- No damping resistor on the PR1_MII0_TXEN signal

[PR1_MII0_TXEN waveform at the Measurement Point]

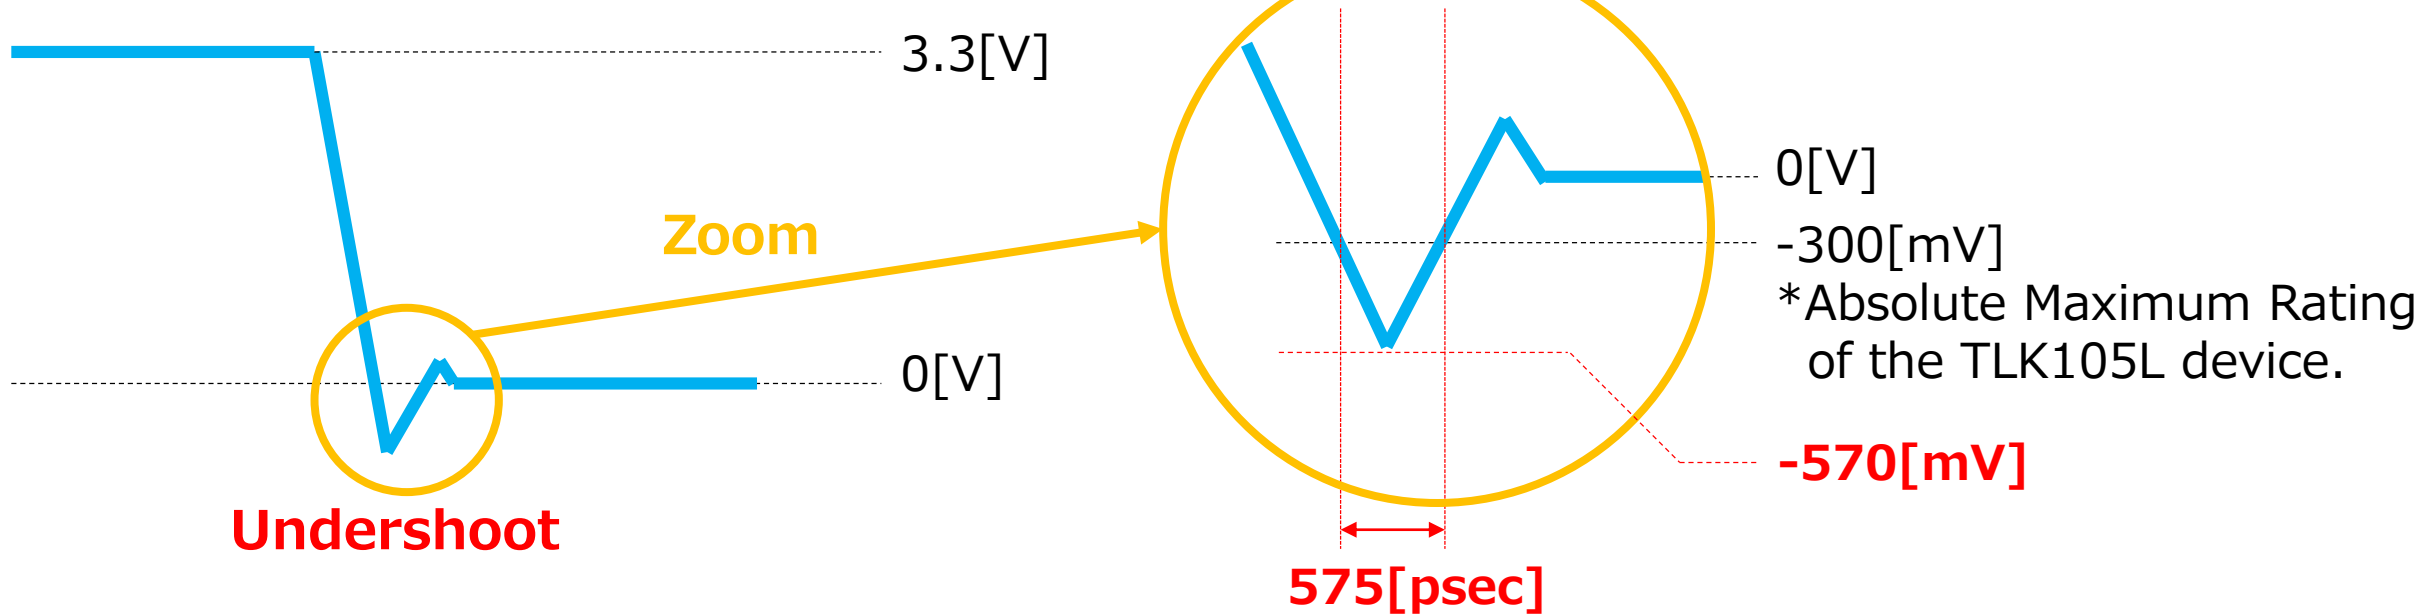
We observed the above undershoot which is beyond the Absolute Maximum Rating (-300[mV]) of the TLK105L(PHY) for 575[psec] and reaches -570[mV].

We know this is un-guaranteed condition, but could you tell us the following?

1. Whether the undershoot could cause immediate and catastrophic damage to the device, or not.
2. Whether the undershoot could cause malfunction, or not.
